Subject: Evaluation of aquifer recharge in areas of planned community applications along the I-84 corridor from Boise to Mountain Home

February 10, 2009 IDWR Memo from
D. Owsley and S. Vincent to S. Lester

Subject: Evaluation of SPF Report entitled *Ground-Water Supply Evaluation for the Mayfield Townsite Property*

Figure 1. SPF and IDWR areas of interest. The proposed Mayfield Townsite development is outlined in black.

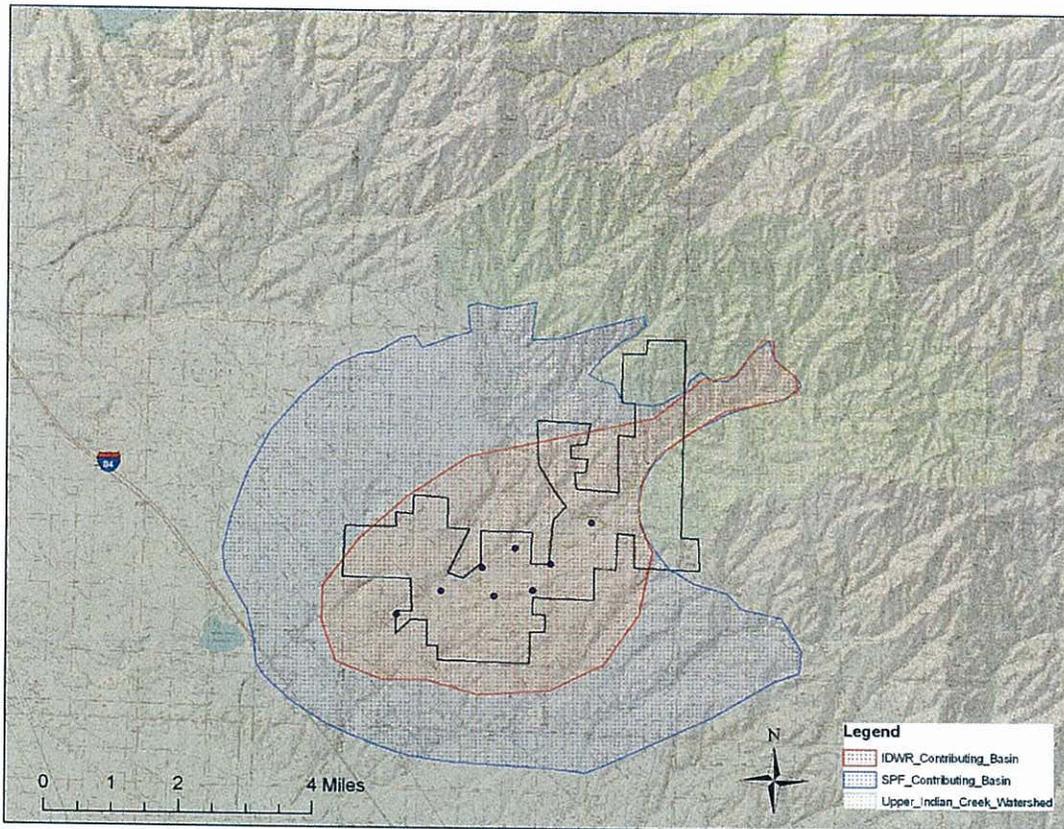
As shown in Figure 1, the resulting 10-year hydraulic capture zone is considerably smaller (18,000 acres) than the “*contributing basin for aquifers in the project area*” (p. 19) that was assumed in the SPF analysis (27,500 acres). The area delineated by IDWR is similar to the area assumed by SPF in the fact that the 10-year travel time was selected arbitrarily. Although actual pumping rates and aquifer properties were used in defining the area, hydraulic gradients and aquifer boundary conditions were not included in the modeling process. Therefore, the resultant area represents the theoretical area in which the production wells would withdrawal water from a flat, infinite aquifer in a 10-year timeframe.

However, the drawdown values that were predicted through the IDWR delineation of the recharge area are not arbitrary. The drawdown values were calculated using the presented transmissivity and estimated pumping values and the ground water gradient and storage coefficient do not influence the predicted drawdown under steady state conditions. The maximum model-predicted drawdown is 130 feet and the drawdown at the northwest boundary of the Cinder Cone CGWA is 81 feet.

Figure 2. Map showing the location of the proposed project site (black outlined area) in relation to ground water management areas.

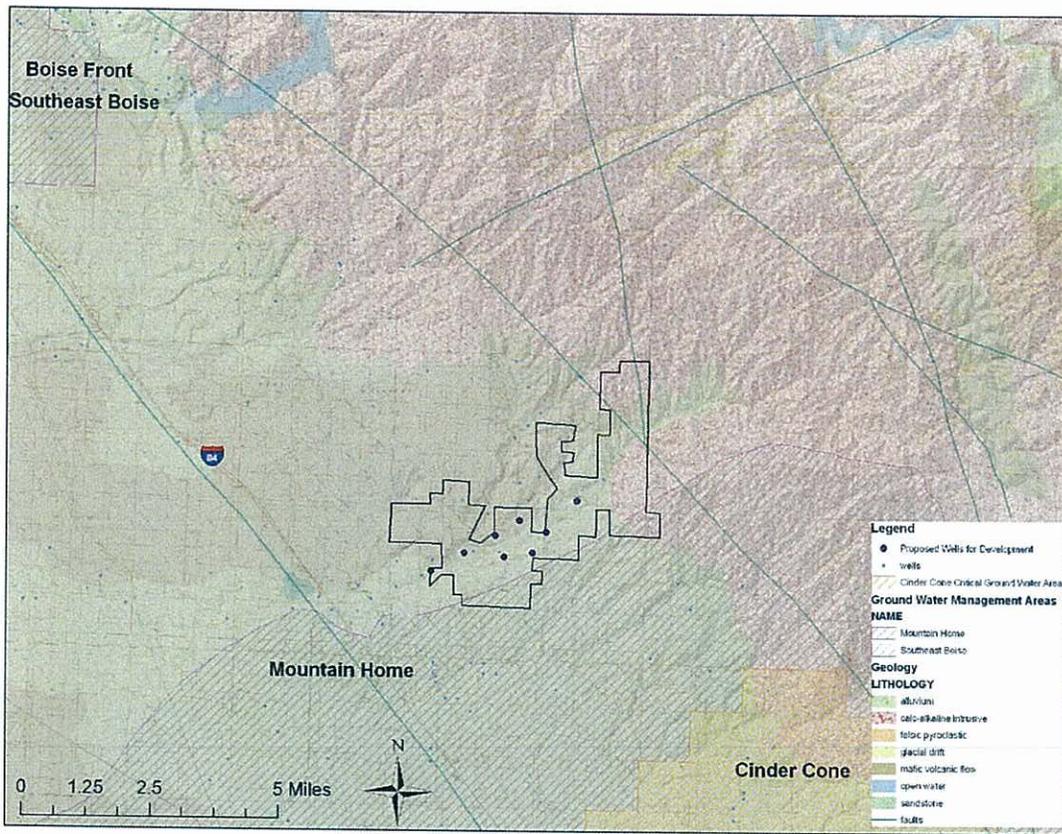
It’s worth mentioning that hydraulic communication between the Mayfield Townsite sedimentary aquifer system and the basalt aquifer in the Cinder Cone CGWA possibly is limited by a fault system that runs along I-84 (Figure 2). The fault system may act as a barrier to flow based upon our preliminary evaluation of available water level data. Assuming that the fault system serves as a partial or complete barrier to flow, the WhAEM-based drawdown estimates are too low for the portions of the management areas that are north of the highway and too high for areas that are south of the highway.

Figure 3. Hydrographs of Indian Creek and Cottonwood Creek. The runoff volume in Indian Creek was estimated by summing the areas of the shaded rectangles. Cottonwood Creek hydrograph was downloaded from <http://waterdata.usgs.gov/nwis/sw>.

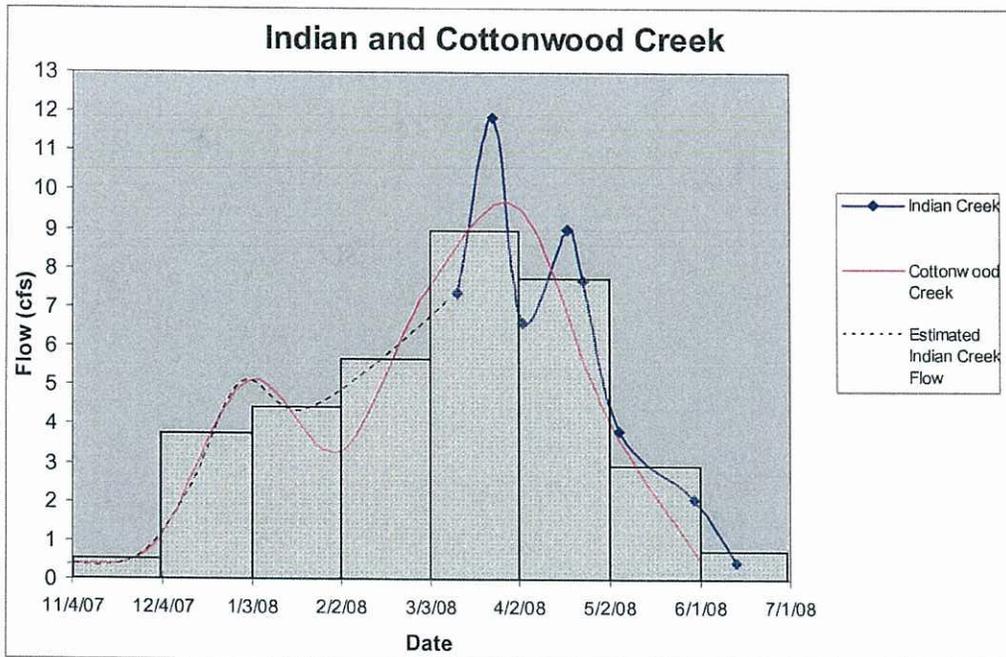
With average to above average snow pack conditions in the Indian Creek watershed this year (2008), we consider the measured flow rates in Indian Creek to be representative of a typical runoff season. However, based on the hydrograph for Cottonwood Creek (USGS Station 13204640), a creek north of Boise that drains a basin of similar physical characteristics (elevation, vegetation, slope, aspect, weather conditions), the runoff season is considerably longer than 3 months. A continuous record of flow in Cottonwood Creek was available for the same period (March-June) as our field measurements. The flow rates are remarkably similar for the period of overlapping measurements (Figure 3). As such, and because the Cottonwood Creek drainage experiences similar weather and has similar physical characteristics, the early season Cottonwood Creek flow data were used to extrapolate the flow data for Indian Creek. The resulting estimated runoff volume for Indian Creek is 2,065 acre-feet for a runoff season that lasts 7 months (Table 3). This is a considerably longer runoff season than the 3-month season that was assumed by SPF.

Based on field observations, the three day temporary flow rate of 100 cfs that SPF included in the water budget was excluded from the IDWR estimate. Coarse sand deposits can be observed along the entire length of the channel down to Indian Creek Reservoir, indicating that not all of the surface flow seeps into the aquifer within the capture area during high flow events.

Figure 4. Water levels in three wells near the Mayfield area with current monitoring data.

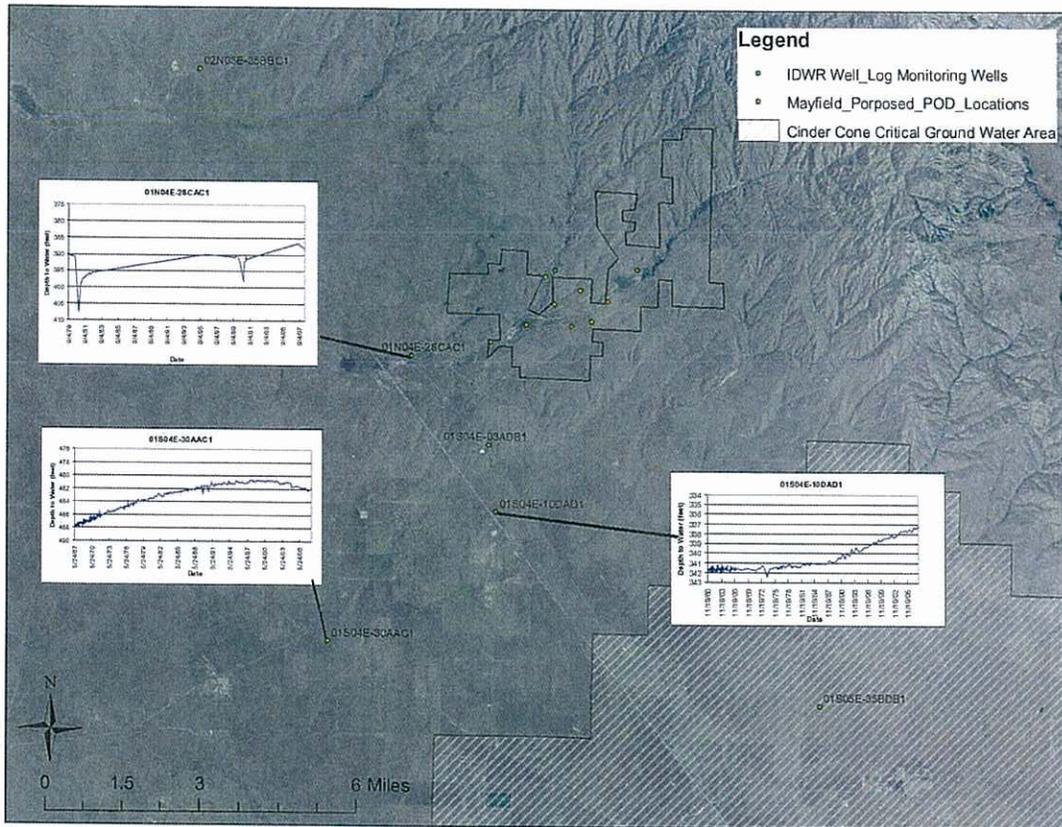
SPF indicates that most water levels in the Mayfield area are either stable or slightly rising (SPF, 2007, pgs. ii, v, and 13). This conclusion is based on IDWR monitoring well data for 16 wells within a 10 mile radius of the development. However, only three of these wells have monitoring data through 2007. Of these three wells, two appear to have increasing trends and the third well appears to be experiencing a declining trend (Figure 4).

It is agreed that the general water level conditions in the Mayfield area are stable or slightly increasing. However, the significance of this trend should not be overemphasized, as it has been shown that the aquifer in this area has historically not experienced significant withdrawal volumes. A significant increase in ground water use in the area has the potential to create declining water levels, similar to those experienced in the Cinder Cone Critical Ground Water Area.
